# Walla Walla Solar Farm Modification 1

Increase in solar panel height  
State Significant Development Modification Assessment  
(SSD 9874 MOD 1)

February 2022

Published by the NSW Department of Planning and Environment

**Figure 4 | Development Footprint and Surrounding Receivers**

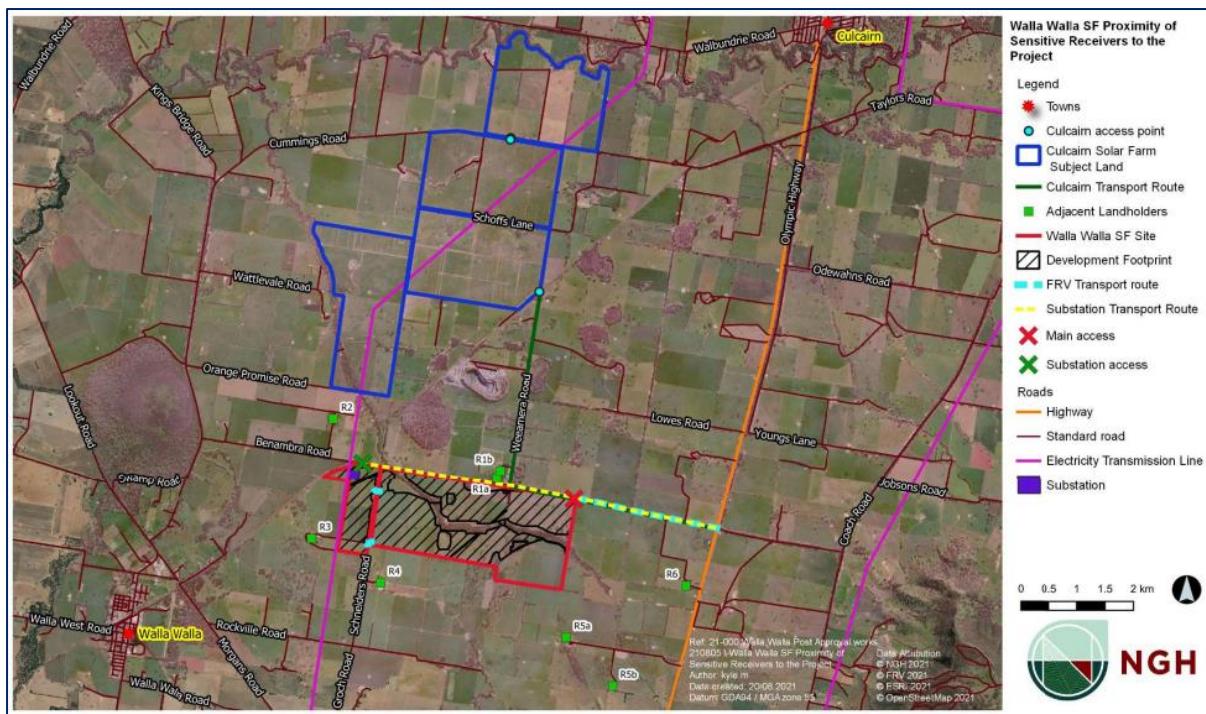
The Department's assessment of the approved project considered visual impacts from the approved project, including 4 non-associated residences (R1a, R1b and R2 and R5a) within 2 km of the project site (see **Figure 4**). The assessment concluded:

The Department acknowledges submissions expressed concern about the visual impacts of the taller panels. An Addendum VIA was undertaken as part of the Modification Report, focusing on the incremental visual impacts of the changes to solar panel and transmission tower heights at Receivers R1, R2 and R5. The Addendum VIA concluded:

- the increase in solar panel height would result in a small increase in the visibility of the project at R1, but these incremental impacts would be minor;
- the change in panel height would not result in a higher residual visual impact for R2 and R5 with the implementation of the proposed mitigation measures; and
- the increase to the substation transmission tower infrastructure is expected to result in a small increase in visibility for R2, although this impact would not result in a higher residual visual impact.

The Department notes that existing conditions of consent incorporate buffers between the solar panel arrays and sensitive receivers, and included requirements for a detailed landscaping plan incorporating FRV's commitments to vegetation screening and retaining boundary vegetation.

The Department considers that the changes in visual impact would be minimal given the distance from receivers and relatively flat landscape. For example, while receiver R1 would experience a small increase in visibility, **Figure 5 to Figure 7** demonstrate that the change in visibility would be limited. Overall, given this minor change, the Department accepts that the residual impacts of the project at each of the receivers would not increase as a result of the modification.
